APPLICATION NO.	FILING DATE	FIRST NAMED INVENTOR	ATTORNEY DOCKET NO.	CONFIRMATION NO.
10/539,996	06/17/2005	Yuqi Zhang	113124-01US	1200
PROCOPIO, CORY, HARGREAVES & SAVITCH LLP 530 B STREET SUITE 2100 SAN DIEGO, CA 92101			EXAMINER	
			MULLER, BRYAN R	
			ART UNIT	PAPER NUMBER
			3723	
			NOTIFICATION DATE	DELIVERY MODE
			11/13/2007	ELECTRONIC

Application No.	Applicant(s)			
	10/539,996	ZHANG, YUQI			
Office Action Summary	Examiner	Art Unit			
	Bryan R. Muller	3723			
The MAILING DATE of this communication app Period for Reply	ears on the cover sheet with the c	orrespondence address			
A SHORTENED STATUTORY PERIOD FOR REPLY WHICHEVER IS LONGER, FROM THE MAILING DA - Extensions of time may be available under the provisions of 37 CFR 1.13 after SIX (6) MONTHS from the mailing date of this communication. - If NO period for reply is specified above, the maximum statutory period w - Failure to reply within the set or extended period for reply will, by statute, Any reply received by the Office later than three months after the mailing earned patent term adjustment. See 37 CFR 1.704(b).	ATE OF THIS COMMUNICATION 36(a). In no event, however, may a reply be tim vill apply and will expire

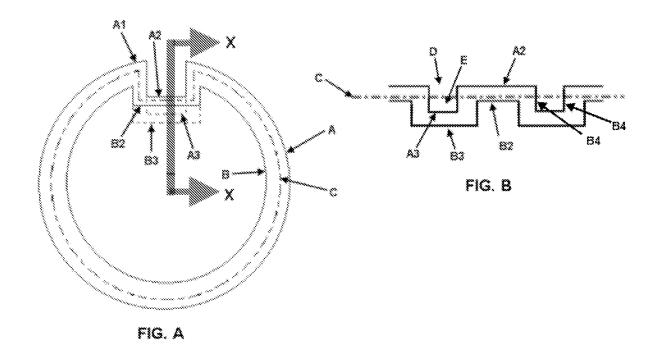
inner pipe is considered to be divided into an inn liner layer and an inner pipe layer. As

seen below in figures A and B (Fig. B is a view along line X-X), when the inner pipe is

divided along staggered line (C), the inner pipe section is provided with a plurality of

detent holes (D) and the inner liner layer, which is fixed to the inner wall of the inner

pipe section will clearly isolate the vacuum of the inner pipe from the detent holes.

- 8. In reference to claim 6, Zhang further discloses that said inner liner layer is an inner liner tube (as shown in Fig. A above) which is provided at its outer wall with a groove (B3 above) extending axially along said inner liner tube and facing said detent holes.

- 9. In reference to claim 7, Zhang further discloses that a clearance (E above) is provided between the outer surface of the inner tube and the inner surface of the

inner pipe, and when the locking device is in the locking state, the detent pin will penetrate through one of the detent holes (D above) into the clearance.

10. In reference to claim 8, Zhang further discloses that said inner liner tube is provided with end sealing members (B4 above) at two ends of said groove to block the clearance between the outer wall of said inner liner tube and the inner wall of said inner pipe.
